3 COMMENTS AND RESPONSES

Figure 4.11-1 Open Hazardous Sites within 0.25 Mile of the Proposed Project (Revised)

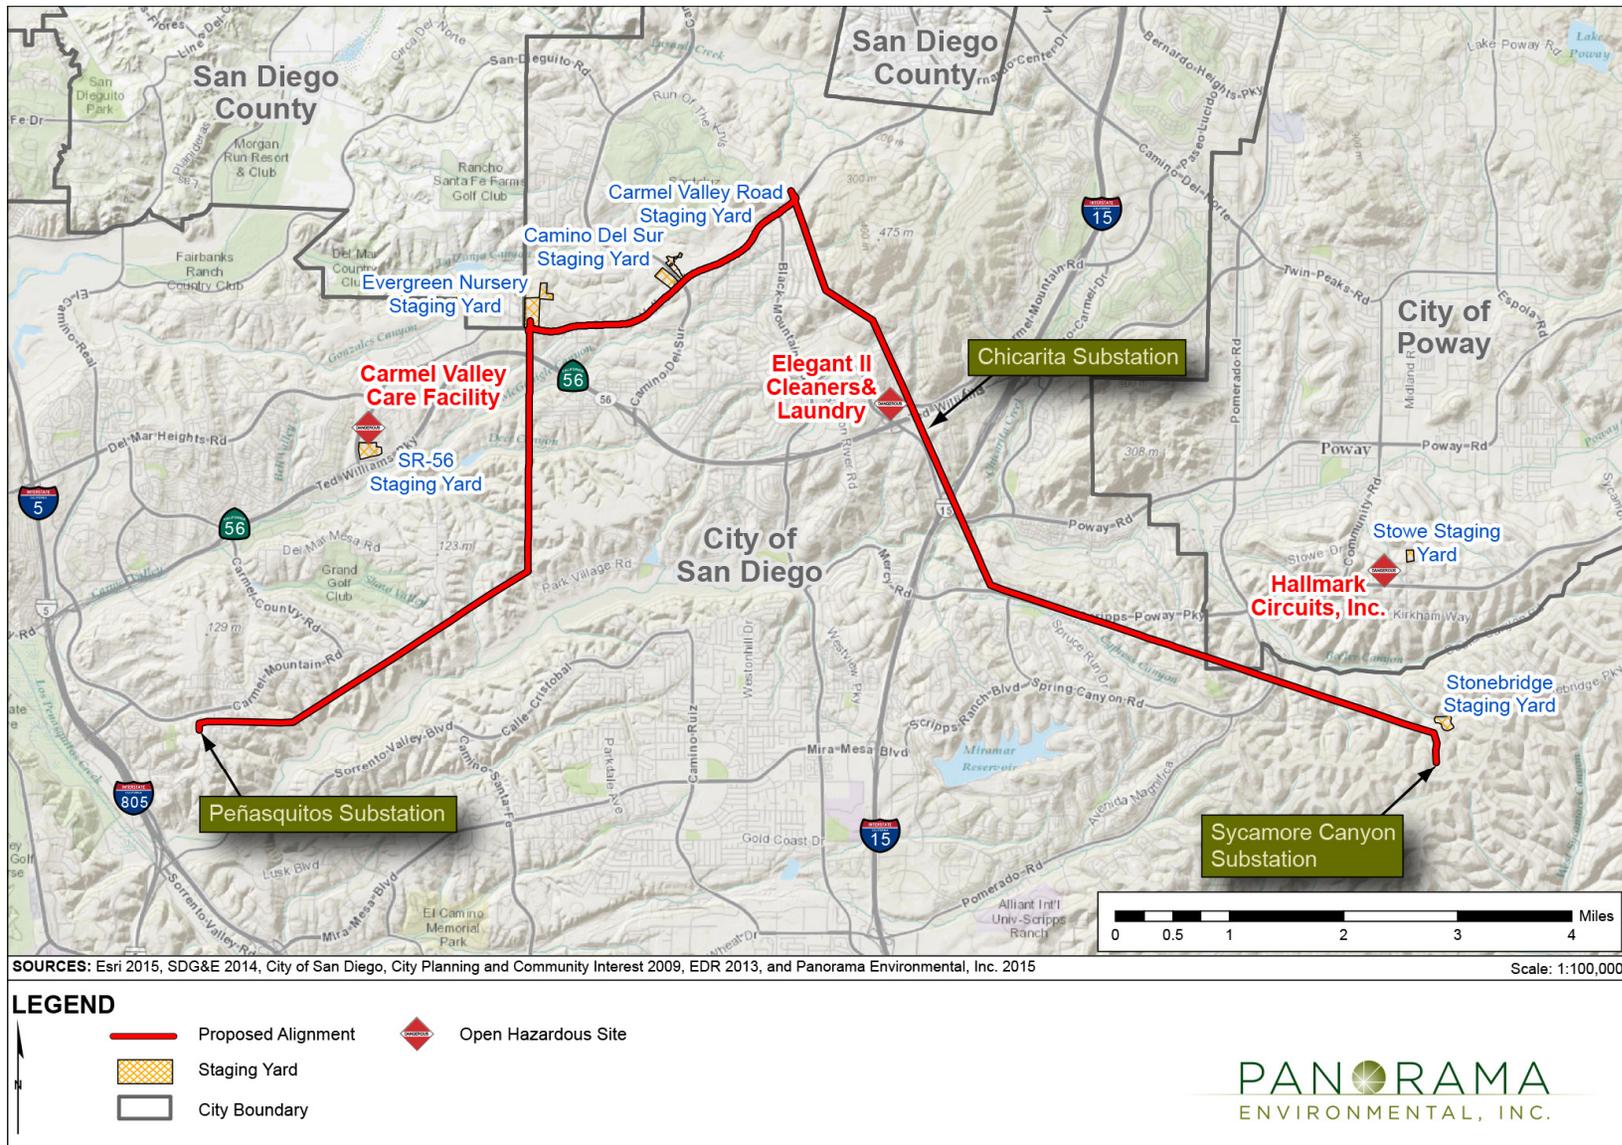
D3-179 The Rancho Peñasquitos Exxon leaking gas storage tank site was closed on August 15, 2015 as indicated in this comment. Table 4.11-1 of the Draft EIR has been updated to reflect the closure of this case:

D3-177 The Rancho Peñasquitos Exxon leaking gas storage tank site was closed on August 15, 2015 as indicated in the comment. The Existing Hazardous Sites portion of Section 4.11.3.2 of the Draft EIR has been revised as follows to reflect the closing of the hazardous site:

Nineteen sites were identified within 0.25 mile of Segment A in the 2013 EDR report and 2015 database search, including three open sites involving the release of hazardous materials. The three sites were reviewed further with the California SWRCB GeoTracker database. It was determined that ~~one-two~~ sites, the Sycamore Canyon Facility ~~and Rancho Peñasquitos Exxon, has have~~ in fact been completed and the cases ~~has have~~ been closed as of August 2013 (SWRCB 2015a) ~~and August 2015 (SWRCB 2015d), respectively~~. The ~~two~~ remaining open site locations ~~are-is~~ shown in Figure 4.11-1 and details for the ~~two~~ open sites ~~are-is~~ summarized in Table 4.11-1.

Figure G-5 Alternative 5 Vegetation Communities and Special-Status Plants in the Biological Survey Area (Map 5 of 6) (Revised)

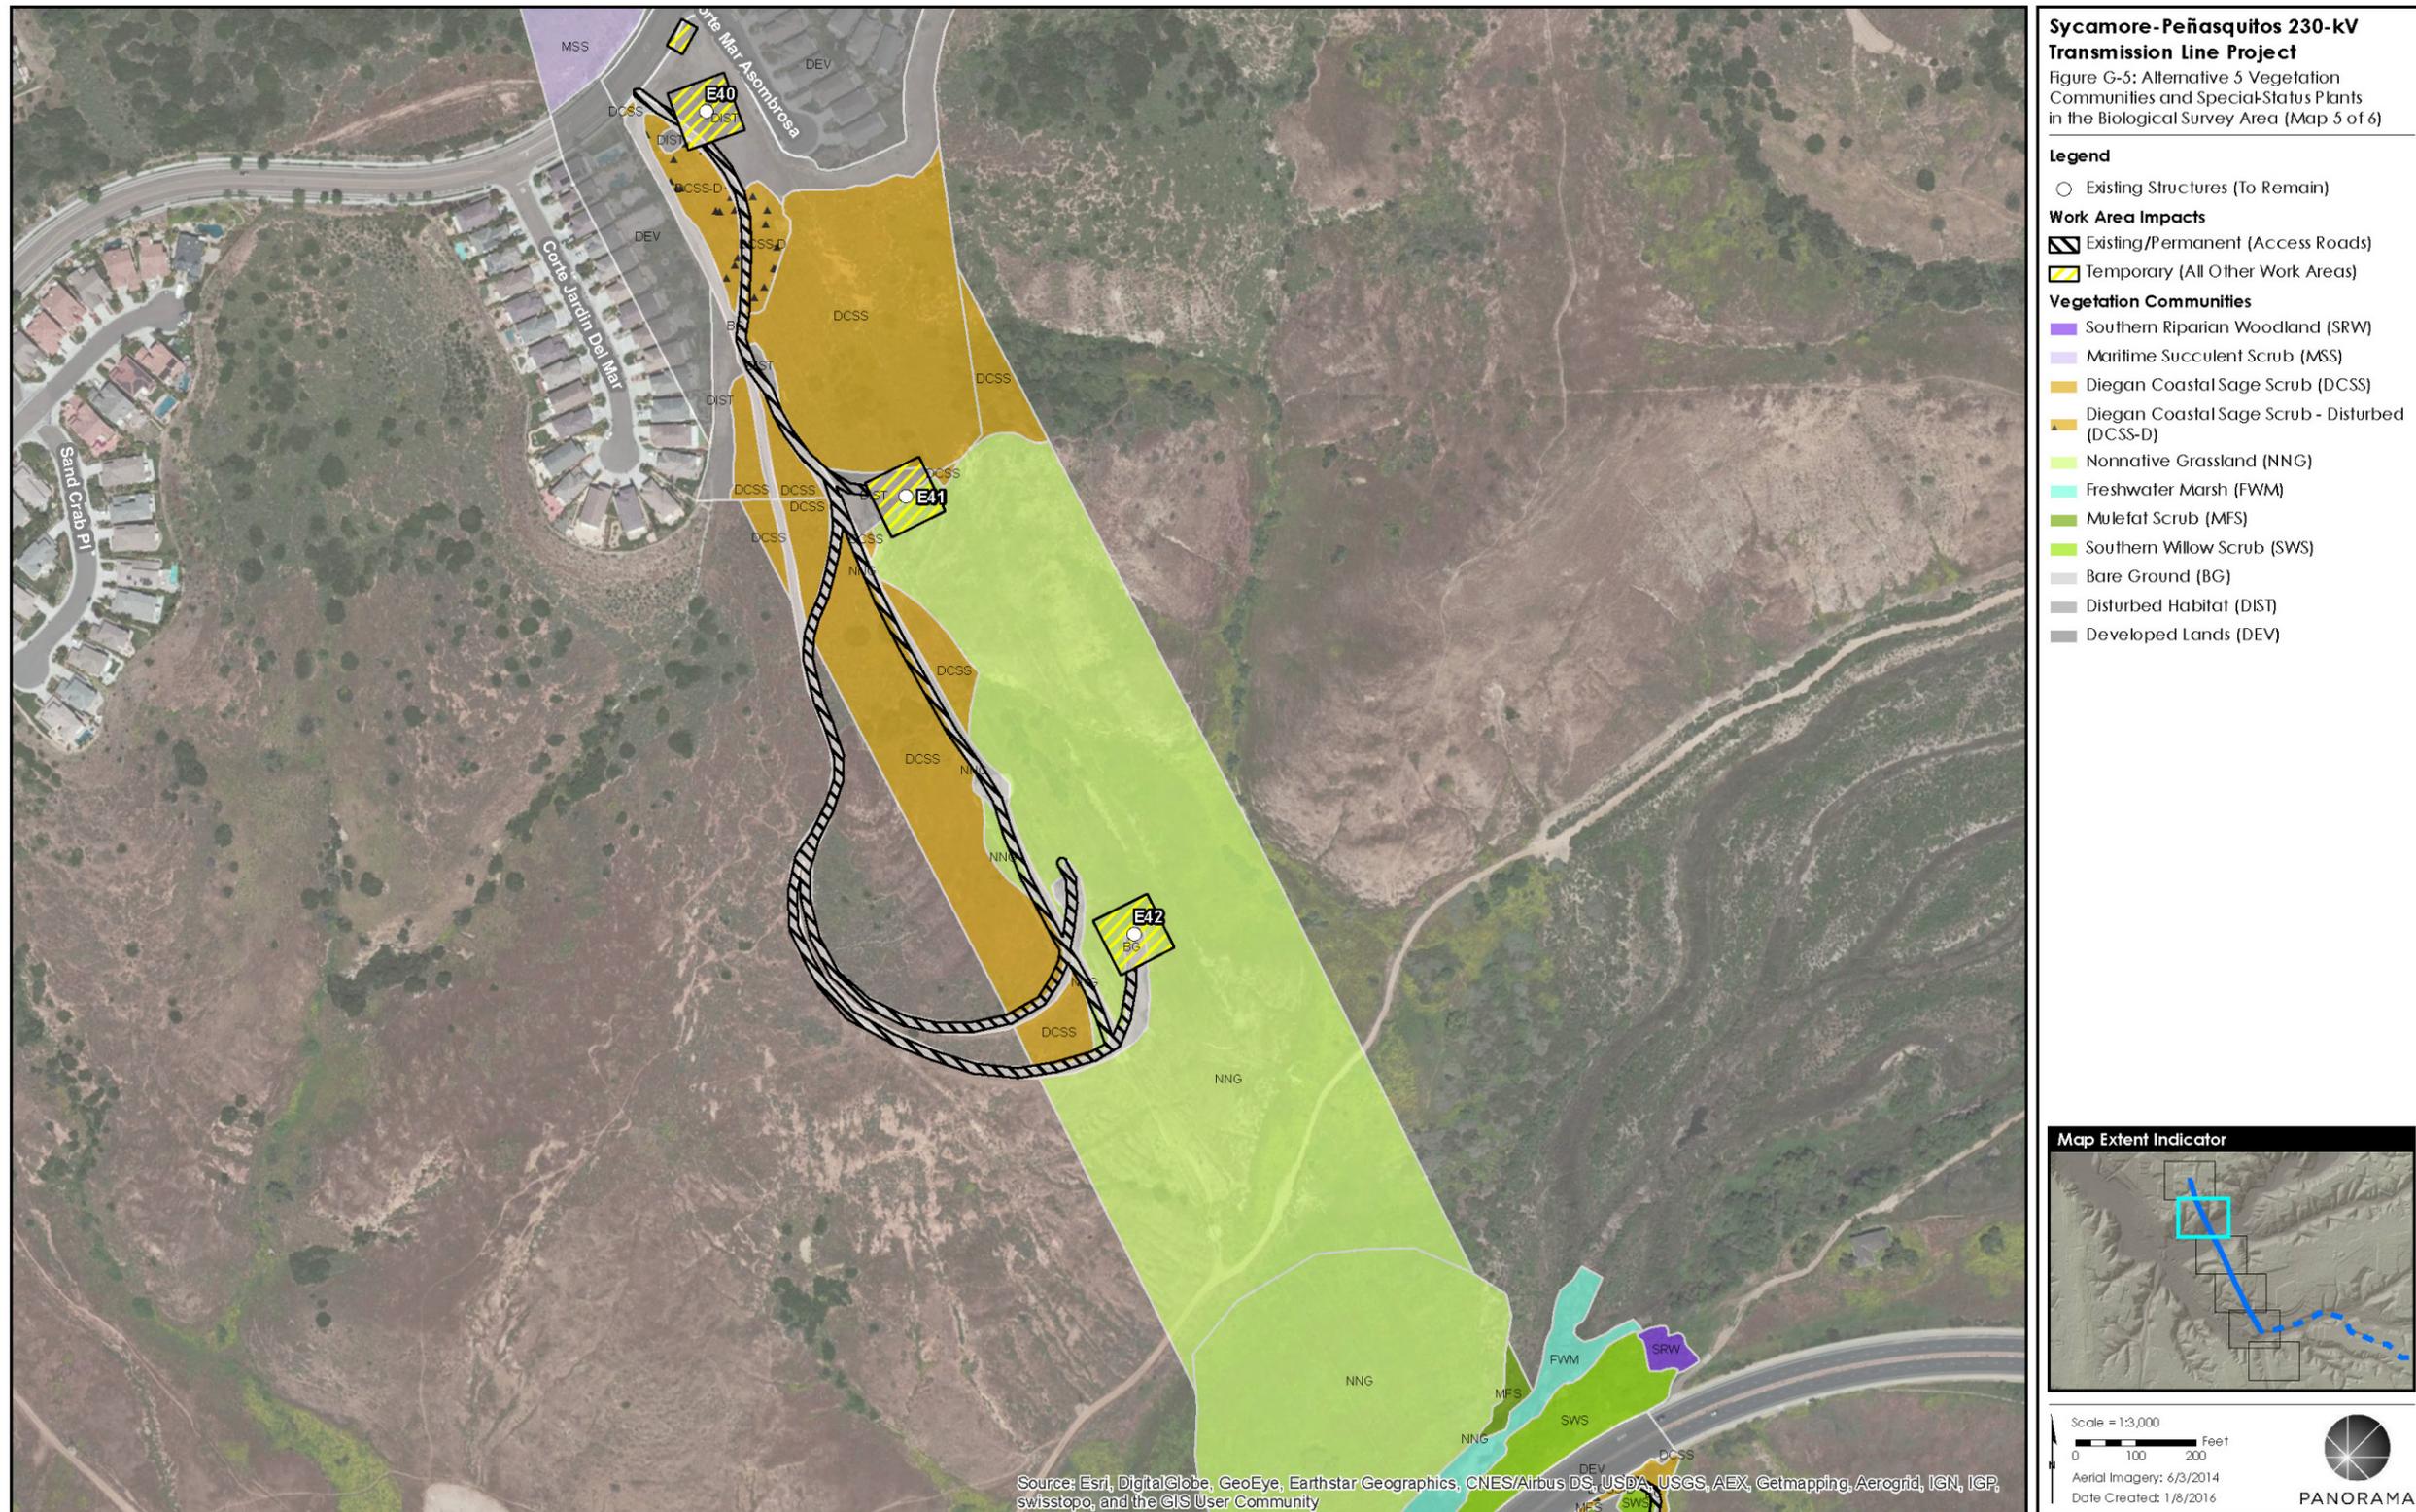
D3-257 The vegetation mapping for Alternative 5 shown in Figure G-5 in Appendix G has been updated as shown on the maps below; these revisions are discussed in detail below. The detailed mapping generally reflects the presence of developed or disturbed habitat in areas that were previously mapped as sensitive vegetation communities within the Alternative 5 alignment. To address SDG&E's comments on the vegetation mapping, a field review was conducted in late December 2015 by biologist, Larry Sward of Helix, Inc.

The revised Figure G-5, Map 5 of 6, with the revisions described above, is shown below.
